DOE/NV--547

Corrective Action Investigation Plan  
for Corrective Action Unit 406: Area 3  
Building 03-74 & Building 03-58  
Underground Discharge Points and  
Corrective Action Unit 429: Area 3  
Building 03-55 & Area 9 Building 09-52  
Underground Discharge Points,  
Tonopah Test Range, Nevada

## NEVADA ENVIRONMENTAL RESTORATION PROJECT DOCUMENT REVIEW SHEET

1. Document Title/Number: Corrective Action Investigation Plan for Corrective Action Unit 406: Area 3 Building 03-74 & Building 03-58 Underground Discharge Points and Corrective Action Unit 429: Area 3 Building 03-55 & Area 9 Building 09-52 Underground Discharge Points, TTR, NV Draft		2. Document Date: March 1999

**Figure 2-1**  
**Cross-Sectional View of a Typical UDP Configuration**

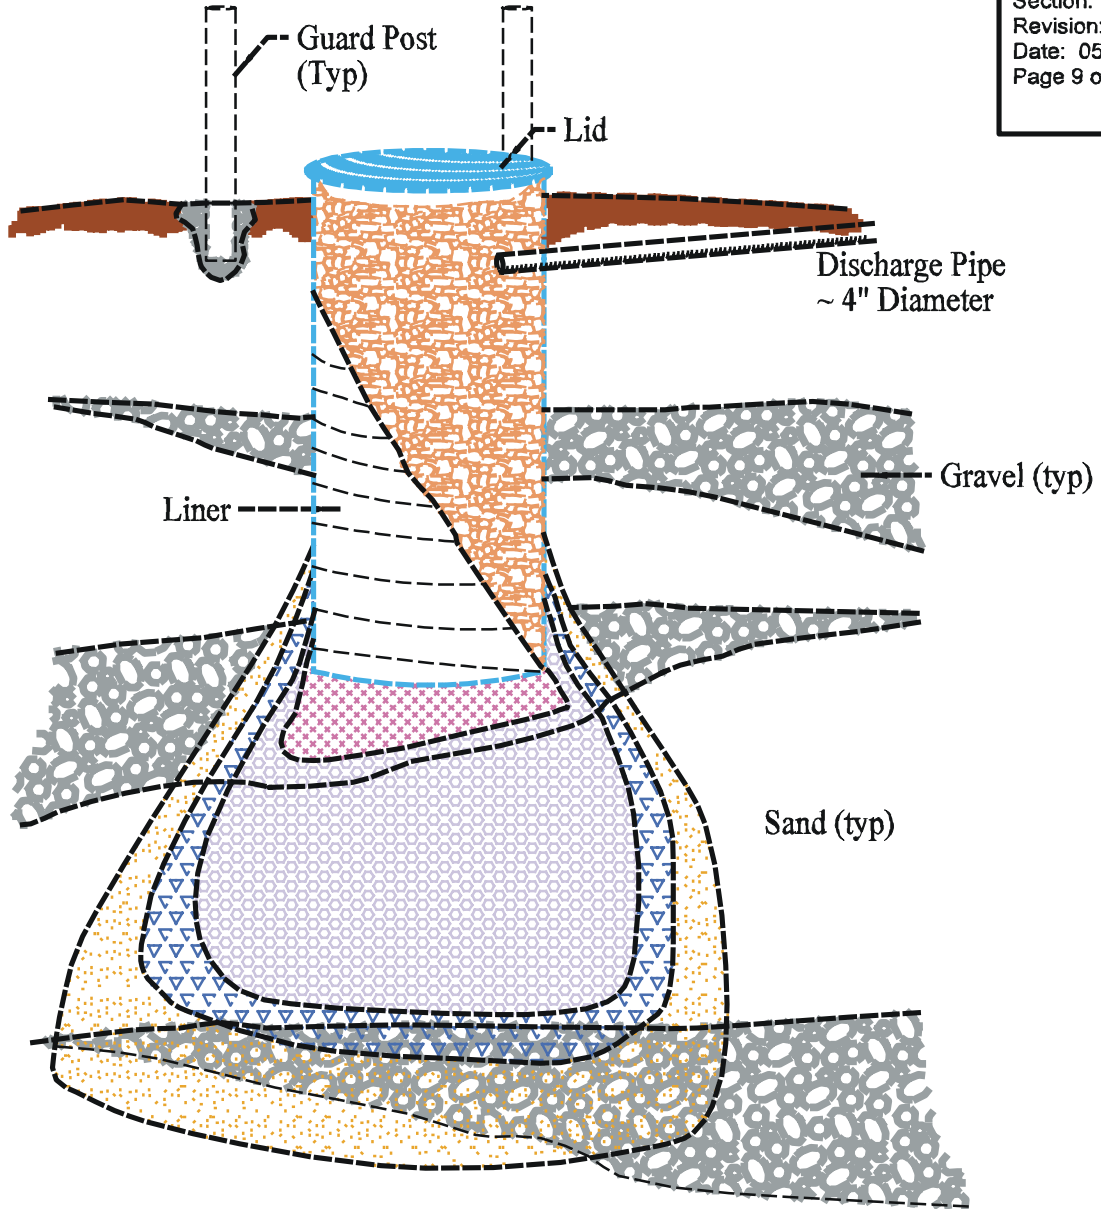
2) Section 3.1 Page 19 of 52, 1 <sup>st</sup> Paragraph After 2 <sup>nd</sup> Sentence		The cross-section in Figure 2-1 depicts a graphical representation of the estimated COPCs	The text has been added.	Yes
